## **E. NEW BUSINESS**

- 1. Kenaitze Estates Subdivision Fall Addition No. 2**  
**KPB File 2024-058**  
**Johnson Surveying / Fall**  
**Location: Funny River Road & Anglers Roost Street**  
**Funny River Area / Funny River APC**

**ITEM #1 - PRELIMINARY PLAT  
Kenaitze Estates Subdivision No. 2**

<b>KPB File No.</b>	2024-058
<b>Plat Committee Meeting:</b>	June 24, 2024
<b>Applicant / Owner:</b>	Randy Fall – 34915 Poppy Wood St., Soldotna, AK 99669
<b>Surveyor:</b>	John Segesser – Segesser Surveys
<b>General Location:</b>	Funny River Road Mile 14, Soldotna, AK / Funny River APC

## Kenaitze Estates Subdivision Fall Addition No. 2

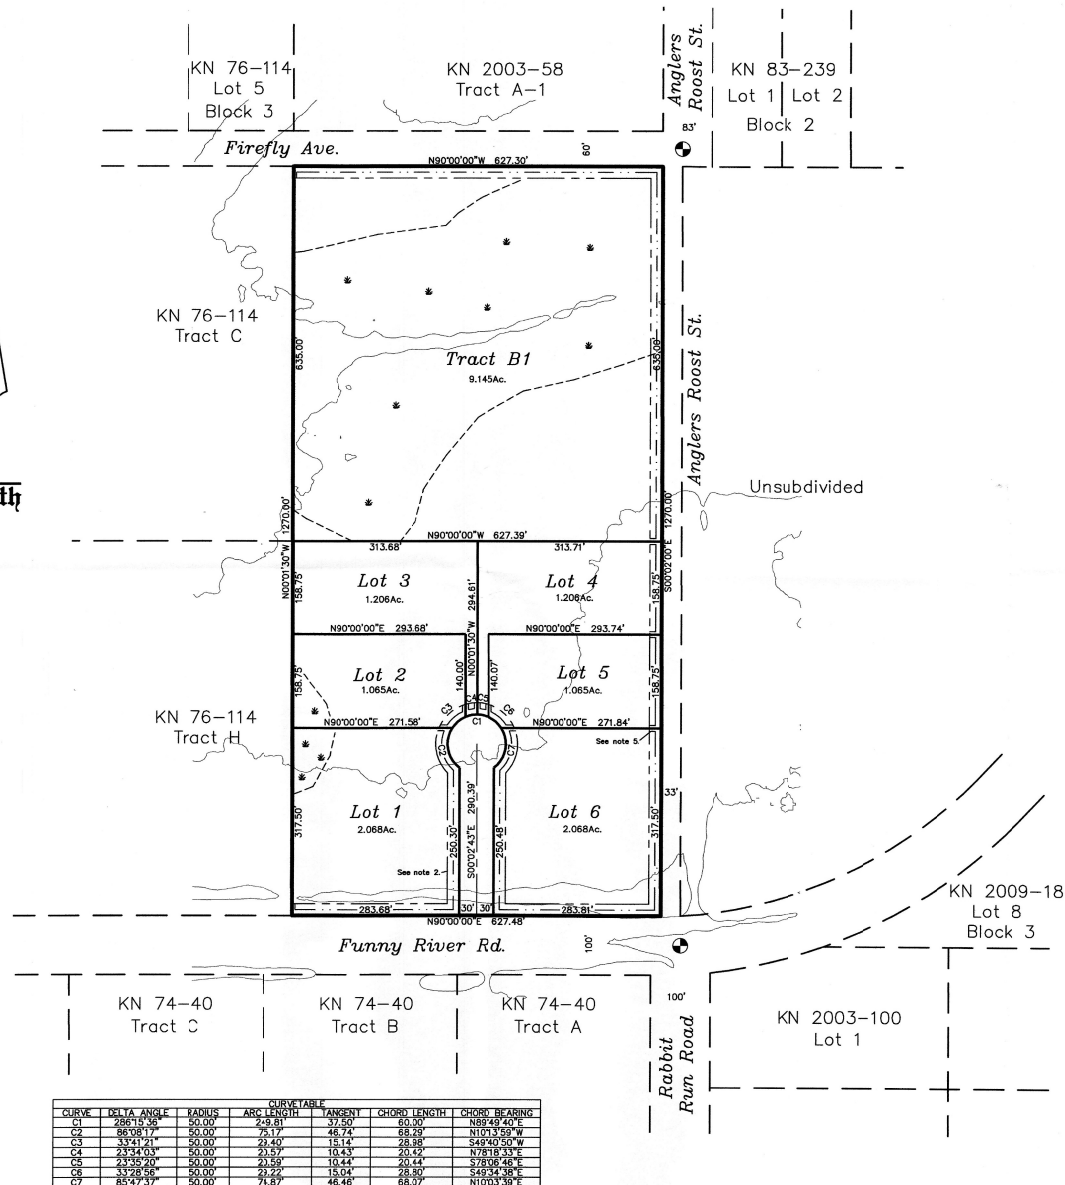
**Location and Legal Access (existing and proposed):** Existing access to the proposed subdivision is from the north side of Funny River Road at approximately mile 14. There is a 50 foot section line easement along Funny River Road that the surveyor needs to verify and show if confirmed.

Anglers Roost St. is a 33' undeveloped dedication provided by dedication along the east of the proposed subdivision and also as a possible 33 foot section line easement then needs verification and shown if confirmed. Firefly Ave. is a 60' undeveloped dedication lying to the north providing access for Tract B1. Funny River Road is a 100' paved and developed state-maintained dedication, accessed from the Sterling Highway.

A 250' foot cul-de-sac dedication is proposed by this platting action which will be accessed from Funny River Road for proposed Lots 1-6. The cul-de-sac is currently unnamed. Staff recommends: the surveyor contact the Addressing Officer and confirm a suitable name for the cul-de-sac to meet standards for a name.

There does appear to be a tower located on proposed lot 1. Filing 2017-010961-0 mentions a occupancy agreement and an exclusive easement that appear to affect this property. Surveyor needs to clarify and note on the plat these items.

<p>There are not any Local Option Zoning District issues with this proposed plat.</p> <p>Material Site Comments: There are not any material site issues with this proposed plat. Communication Tower, driveway and utilities should be shown/labeled in the Southwest corner of Lot 1.</p>
Assessing	<p>Reviewer: Windsor, Heather</p> <p>Comments: No comment</p>
Advisory Planning Commission

- Update KPB file number to 2024-058.
- Lot 8 to the east needs Block changed to 1
- Provide KPB approved name for cul-de-sac.
- Add Certificate of Acceptance.
- Depict and provide detail on plat to match items in legend.

**Staff recommendation:**  
Depict section line easement along eastern & southern boundary of section.
- D. A vicinity map, drawn to scale showing location of proposed subdivision, north arrow if different from plat orientation, township and range, section lines, roads, political boundaries, and prominent natural and manmade features, such as shorelines or streams;

**Staff recommendation:**  
*Label Anglers Roost St and remove Lake St on vicinity map*
- F. The location, width and name of existing and platted streets and public ways, railroad rights-of-way, easements, and travel ways existing and proposed, within the subdivision;

**Staff recommendation:** Provide name for cul-de-sac.

**Staff recommendation:** place the standard note on the plat for the flag lot(s): No structures are permitted within the panhandle portion of the flag lot(s).

Depict and provide detail on plat to match items in legend.

Add Certificate of Acceptance.
